Beach Drive Bridge (M-PK24) over Silver Creek (CIP Project No. 509132), Mandatory Referral No. MR2019001

Mandatory Referral MR2019001: Bridge M-PK24 – Beach Drive Bridge Over Silver Creek

- Applicant: Montgomery County Department of Transportation
- Filing Date: July 16, 2018. 60-day review extended by consent of MCDOT

Signing and Marking Plans

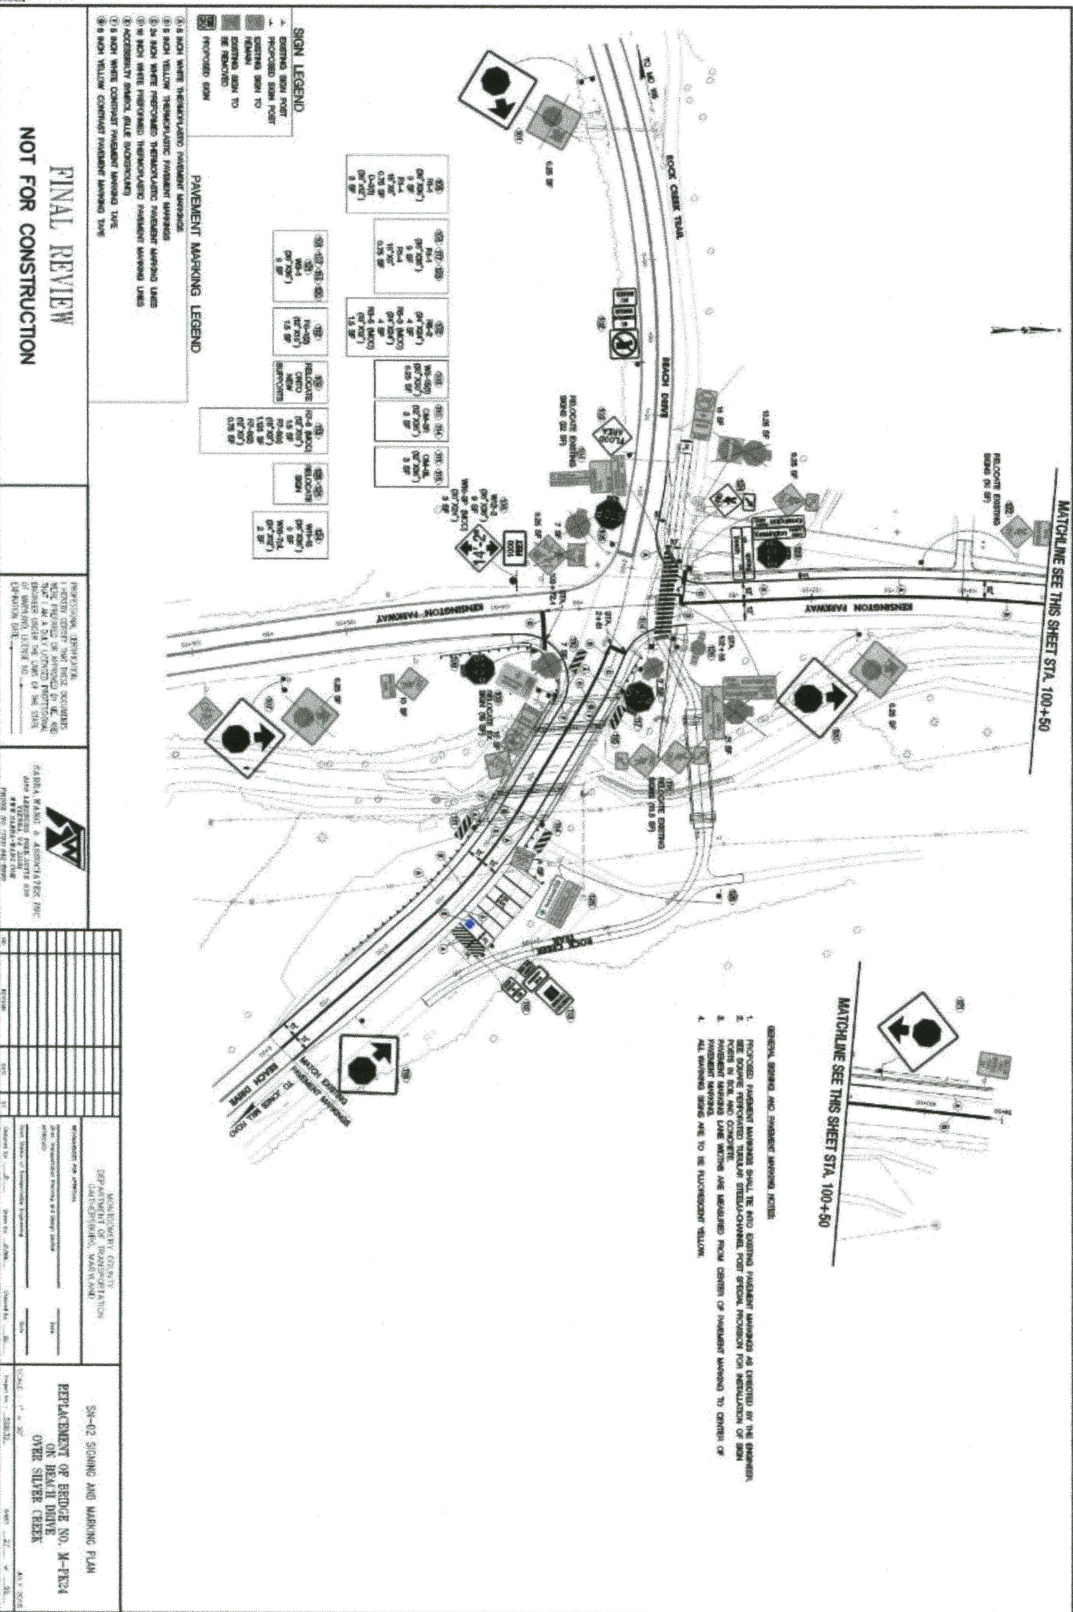
1. Submit roadway and stream restoration construction plans to the M-NCPPC Department of Parks for review as part of the park permit process to ensure that all work on parkland is performed in accordance with M-NCPPC standard details, specifications, and policies.
2. Stripe crosswalks across the north and east legs of the intersection at Kensington Parkway and Beach Drive.
3. When the existing bridge on Kensington Parkway over Rock Creek (M-NCPPC Montgomery Parks Bridge NoM0073) is improved in the future, the planned sidepath on the eastern side of Kensington Parkway between Jones Bridge Road and Bexhill Drive should be studied and completed in conjunction with that project.
4. Limits of disturbance on the Sediment Control Plan must match the limits of disturbance shown on Forest Conservation Exemption Plan No. 42018092E.
